DEPARTMENT OF THE AIR FORCE
AIR FORCE BASE CONVERSION AGENCY

SUBJECT: Submittal - Primary Document - Final Supplemental Investigations Report

Final Response to Comments Draft Report for Supplemental Investigations of Areas of Concern Griffiss Air Force Base Submitted November 1997

Comments on Draft SI Report sections by Dean Williams, U.S. Army Corps of Engineers, Kansas City District, Dated November 1997.

Figure 4.11.4.8-1
SUPPLEMENTAL INVESTIGATION
SAMPLE LOCATION AND
GROUNDWATER CONTOUR MAP
BUILDING 101
BADP/YELLOW SUBMARINE UST SITE

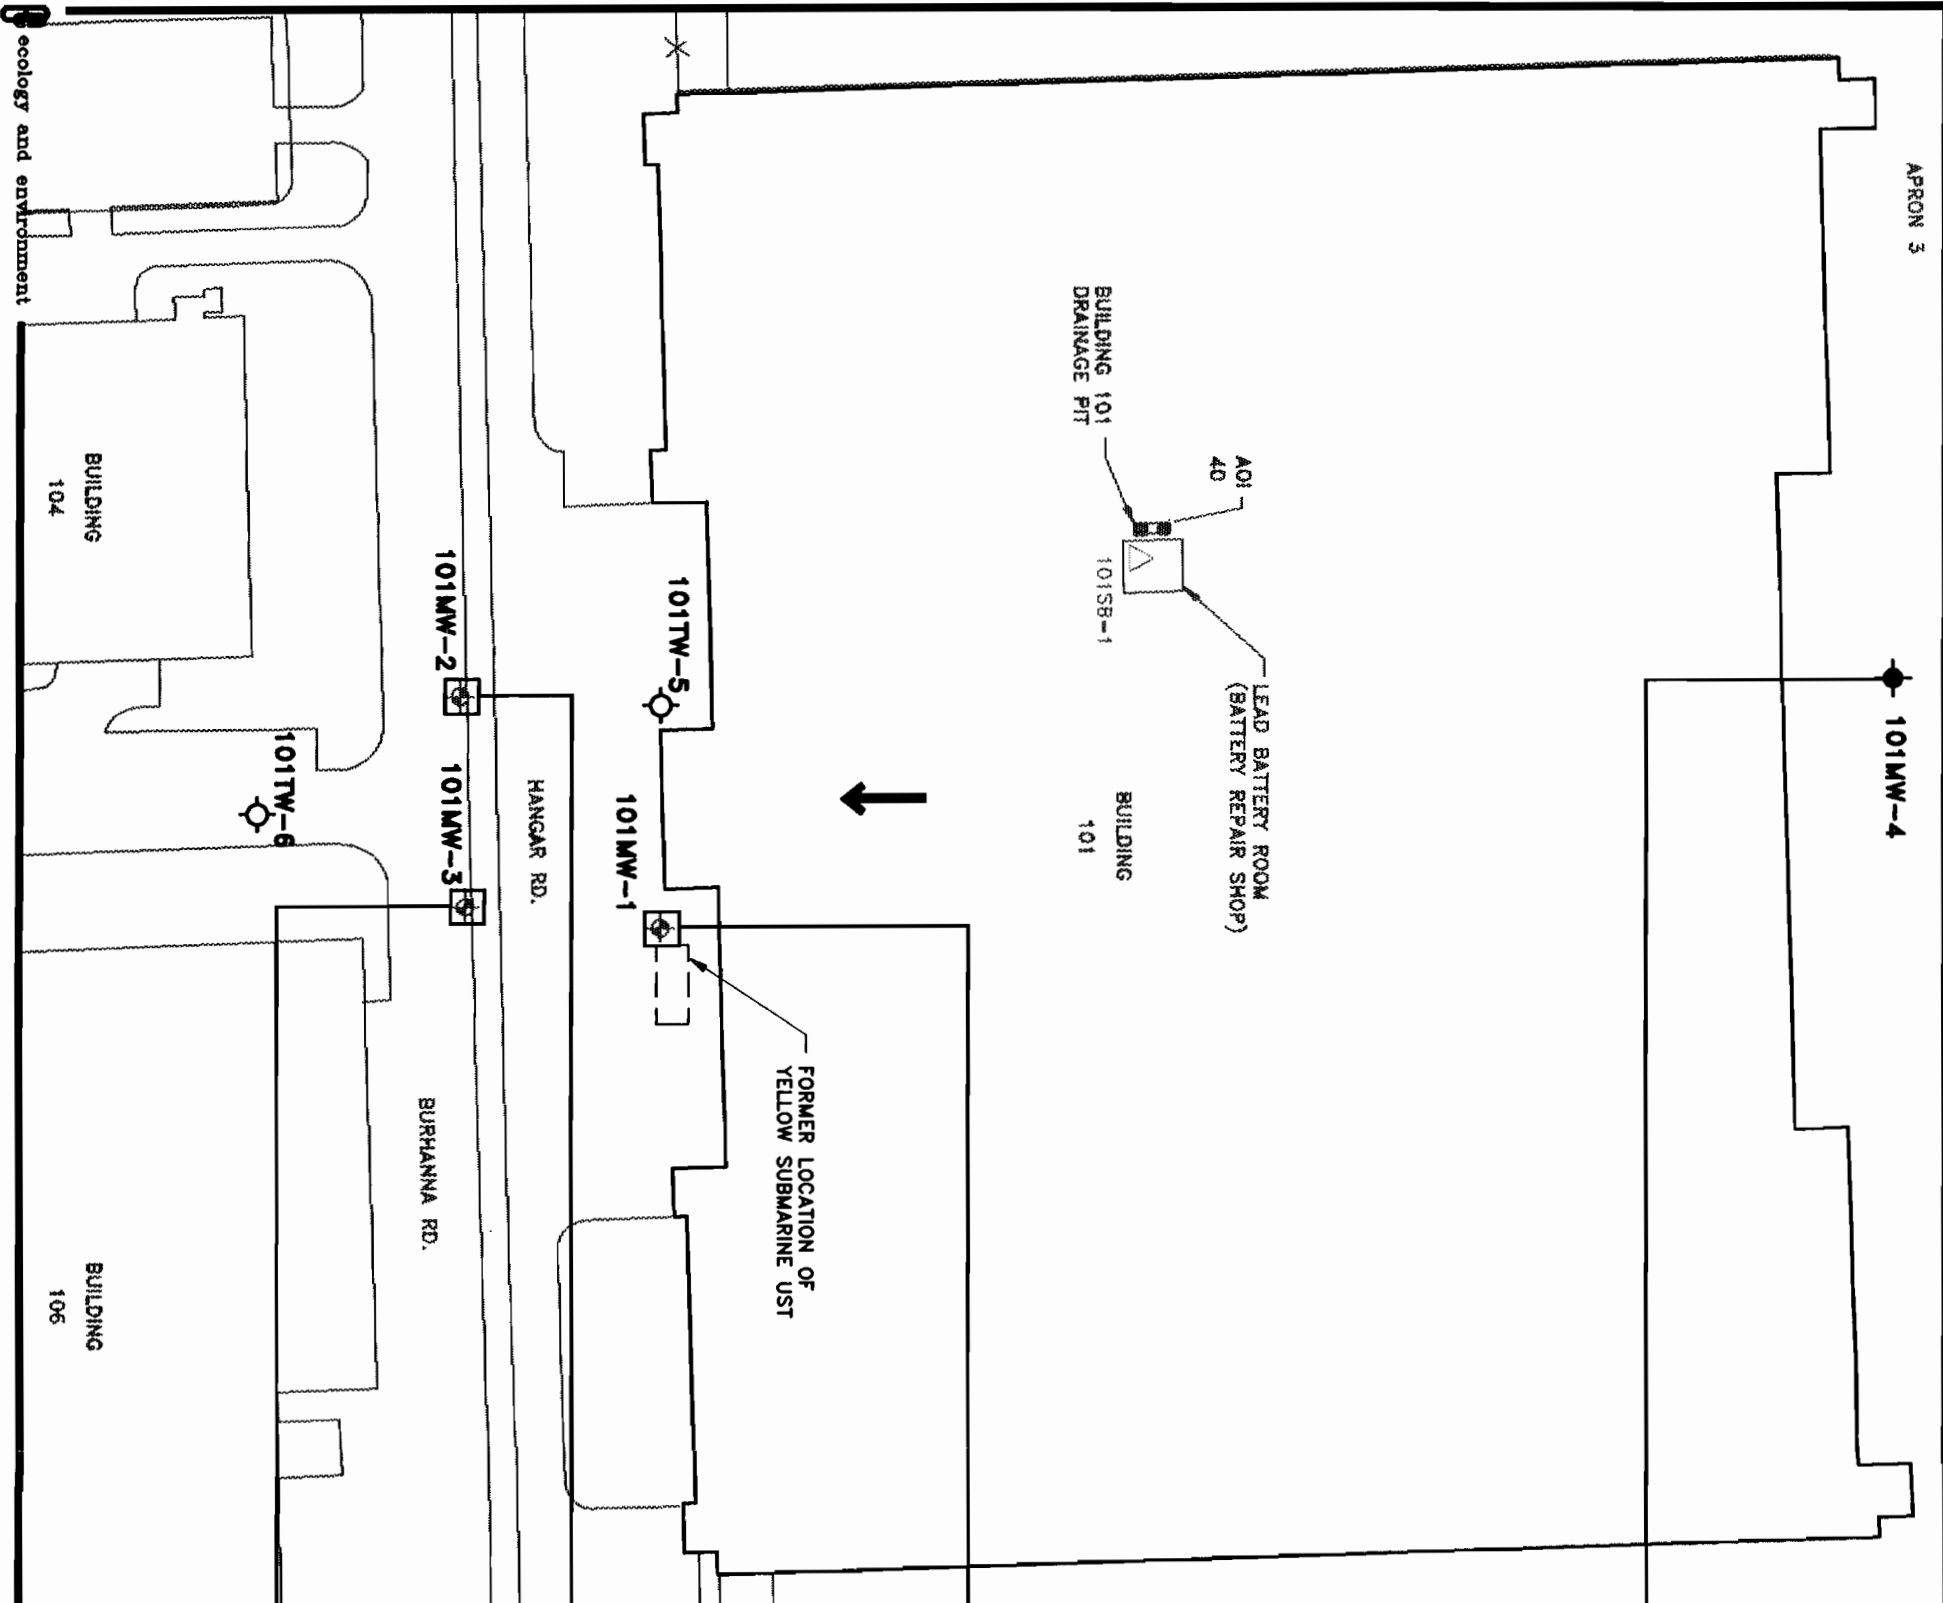
Figure 4.11.4.8-1: Modified contour line.

Figure 4.11.4.9-1
SUPPLEMENTAL INVESTIGATION
SAMPLE LOCATION AND
GROUNDWATER CONTOUR MAP
LANDFILL 5

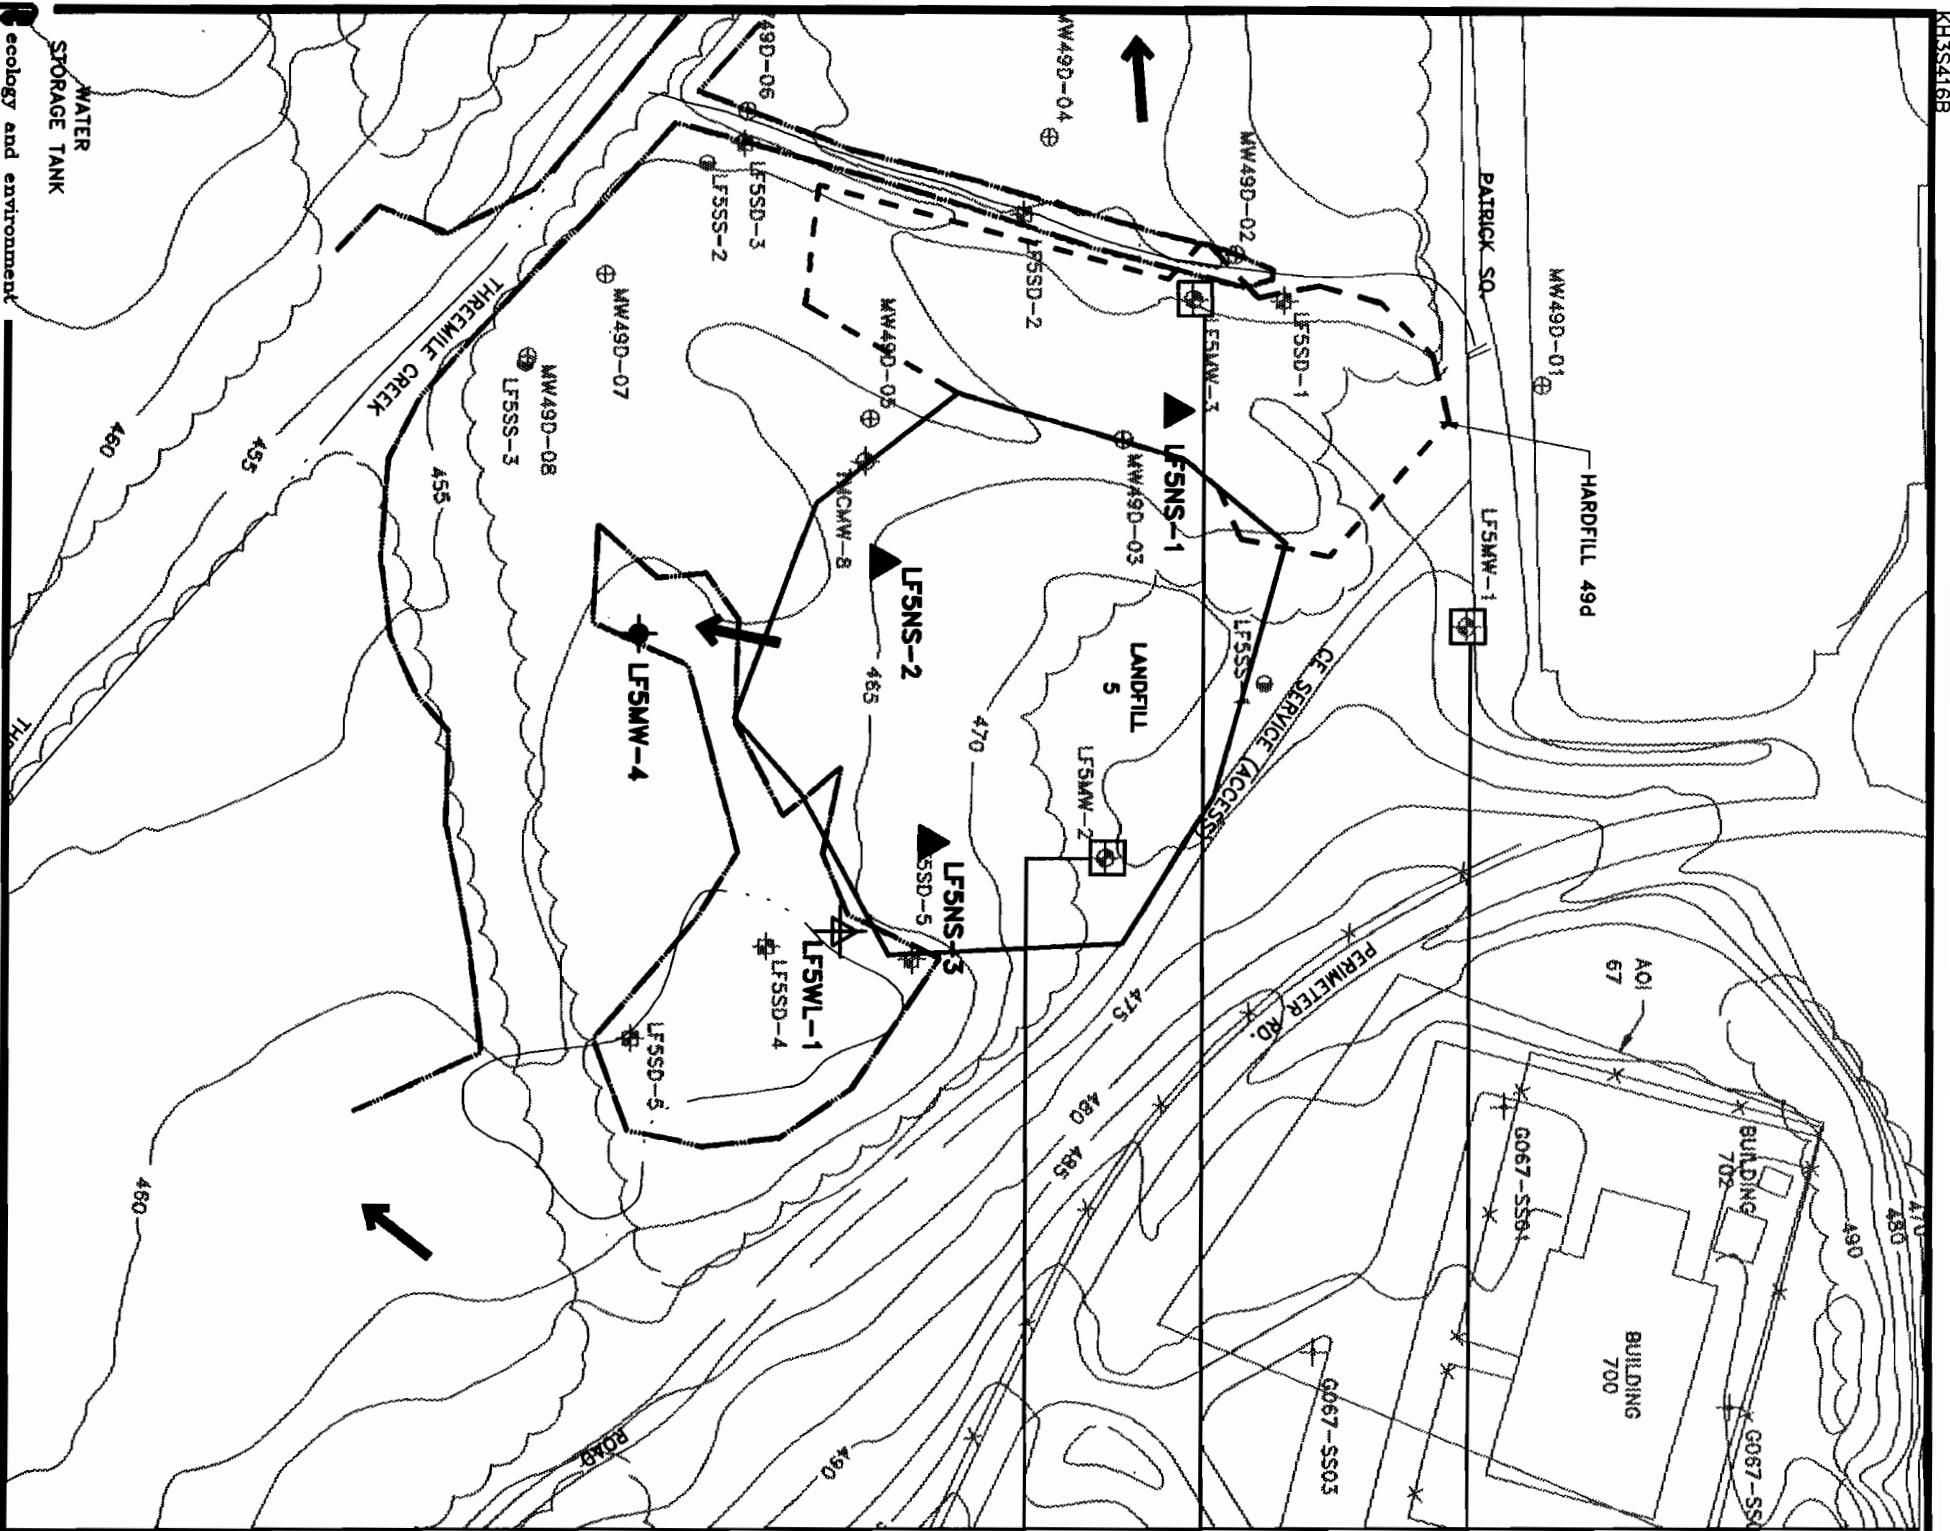
In addition, the direction of groundwater flow, identified on Figure 4.11.4.9-1, is different from the flow presented in the RI. A discussion should be provided in the text that explains why the direction of groundwater flow is different than previously thought.

Figure 4.11.4.11-1
SUPPLEMENTAL INVESTIGATION
SAMPLE LOCATION AND
GROUNDWATER CONTOUR MAP
BUILDING 775 (PUMPHOUSE 3)

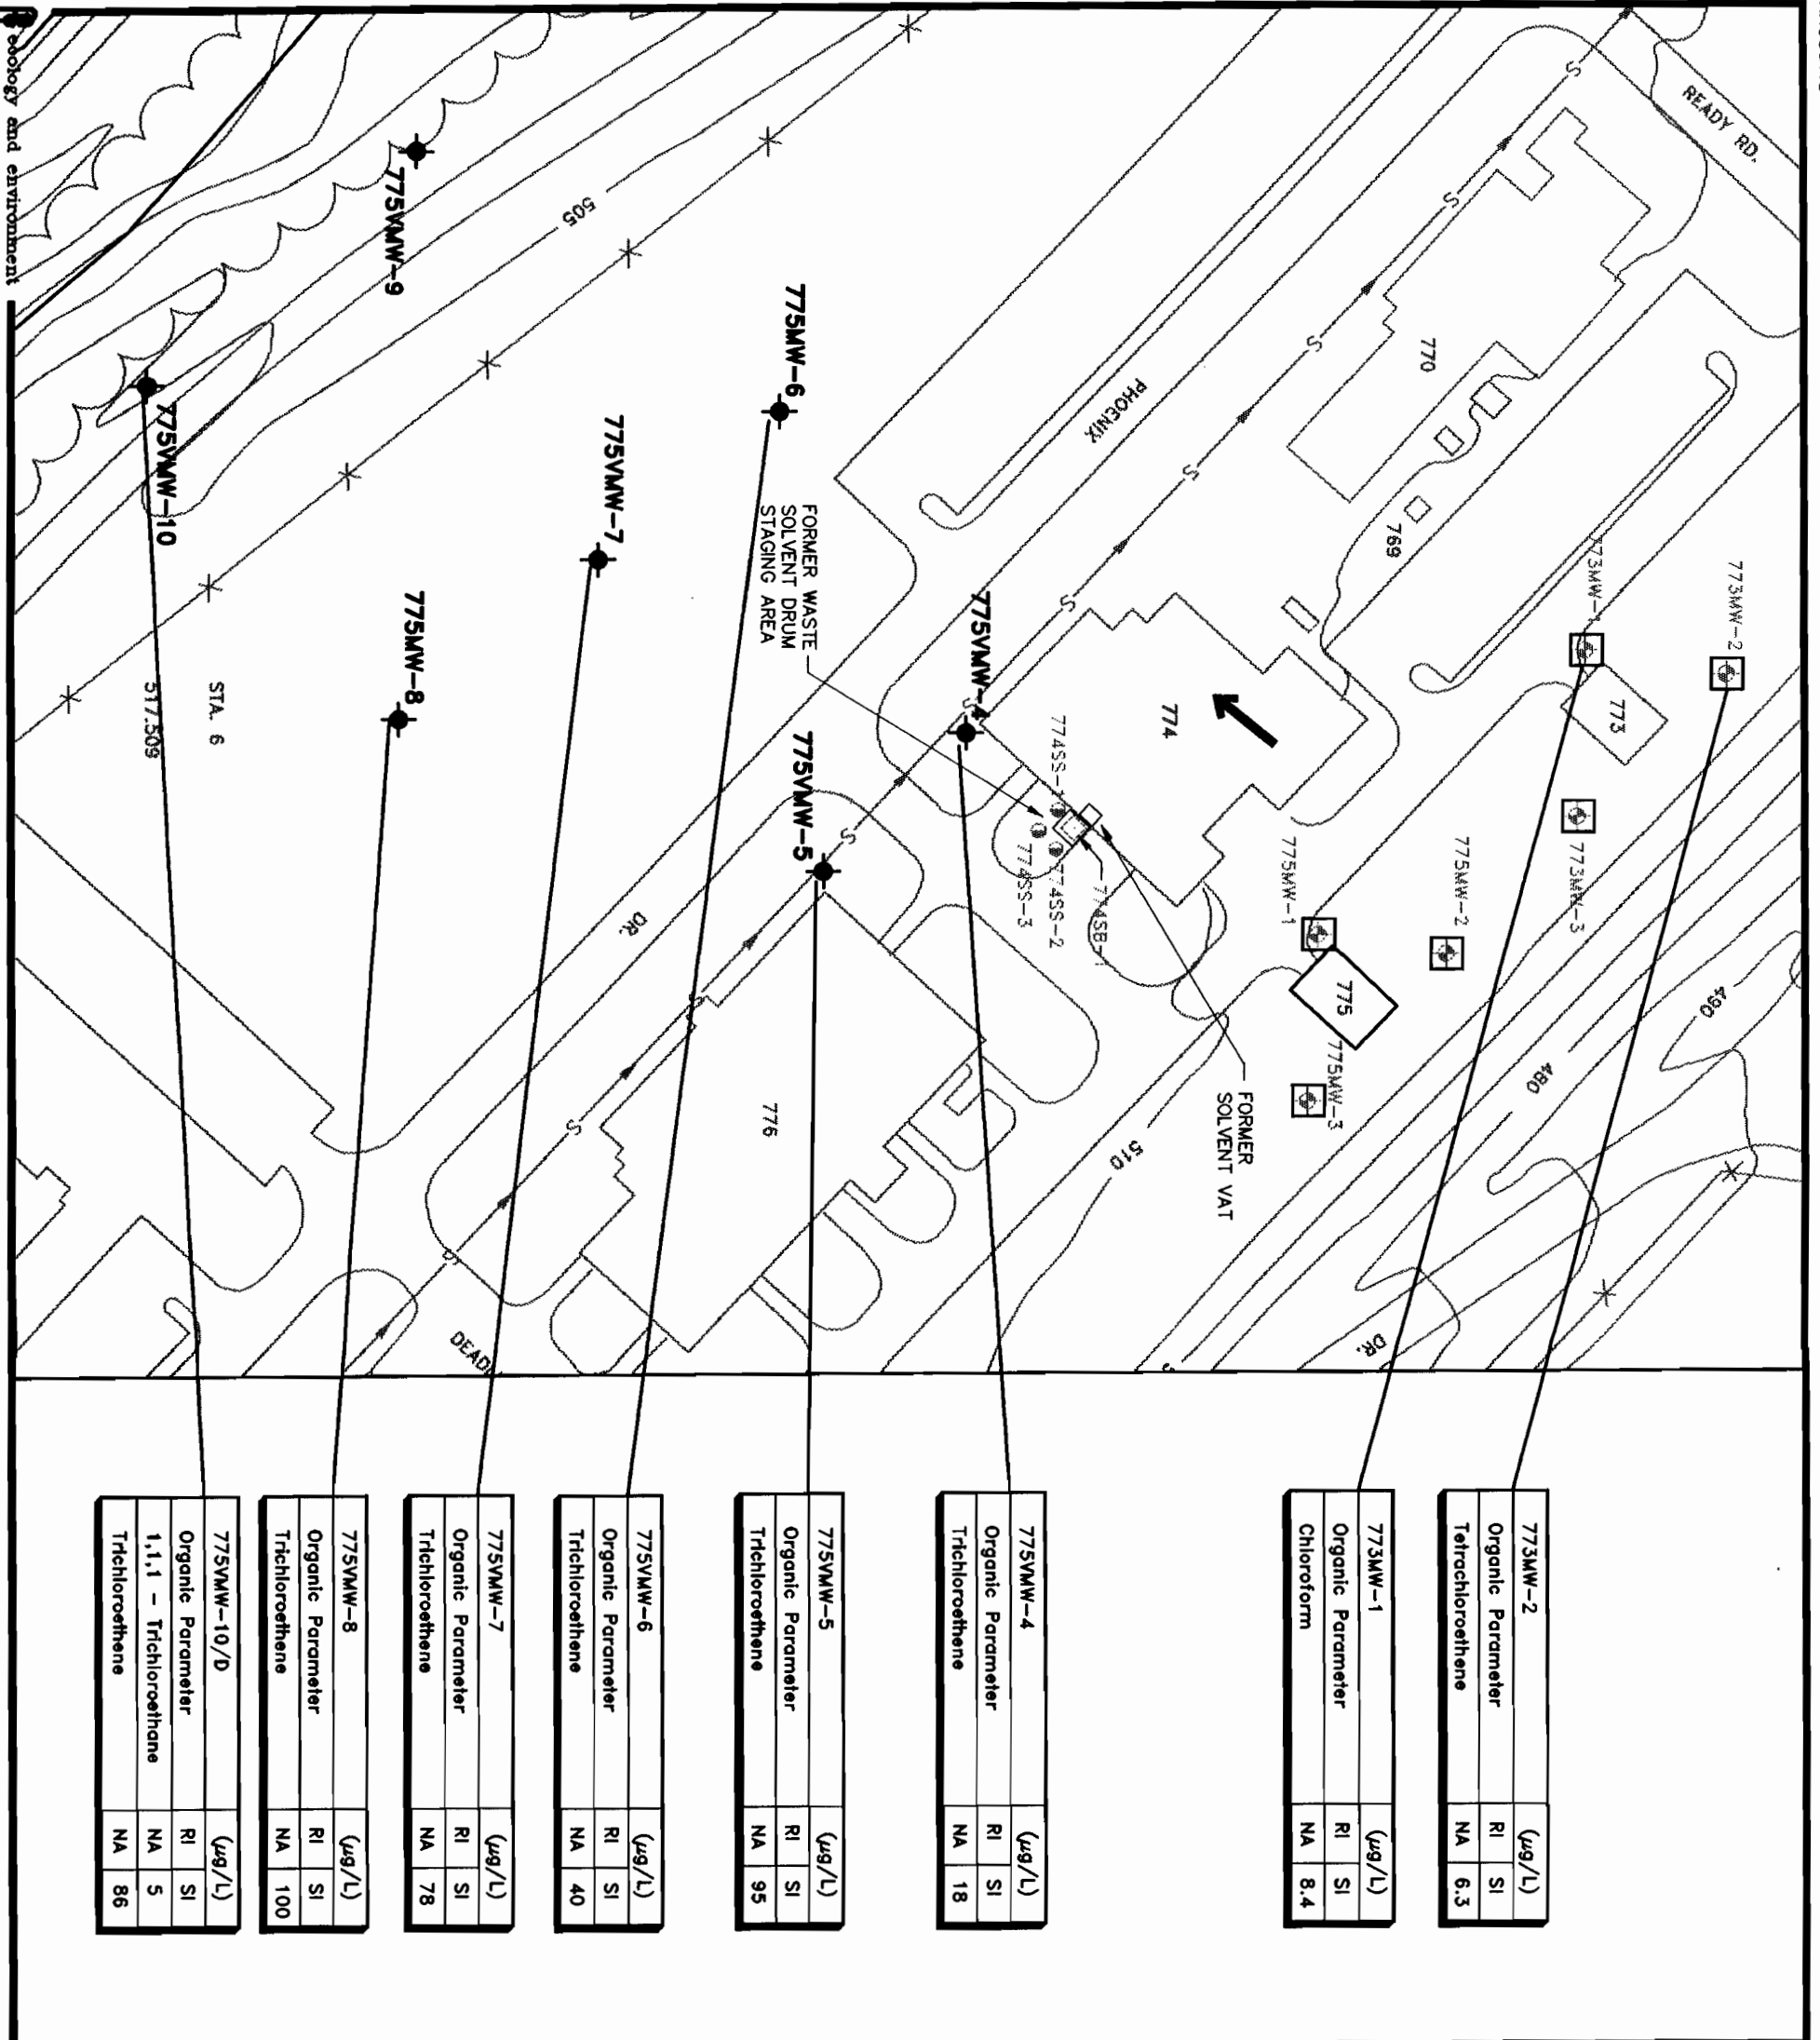
Figure 4.11.4.11-1: Modified contour lines and added 775VMW-9 and 775VMW-10.
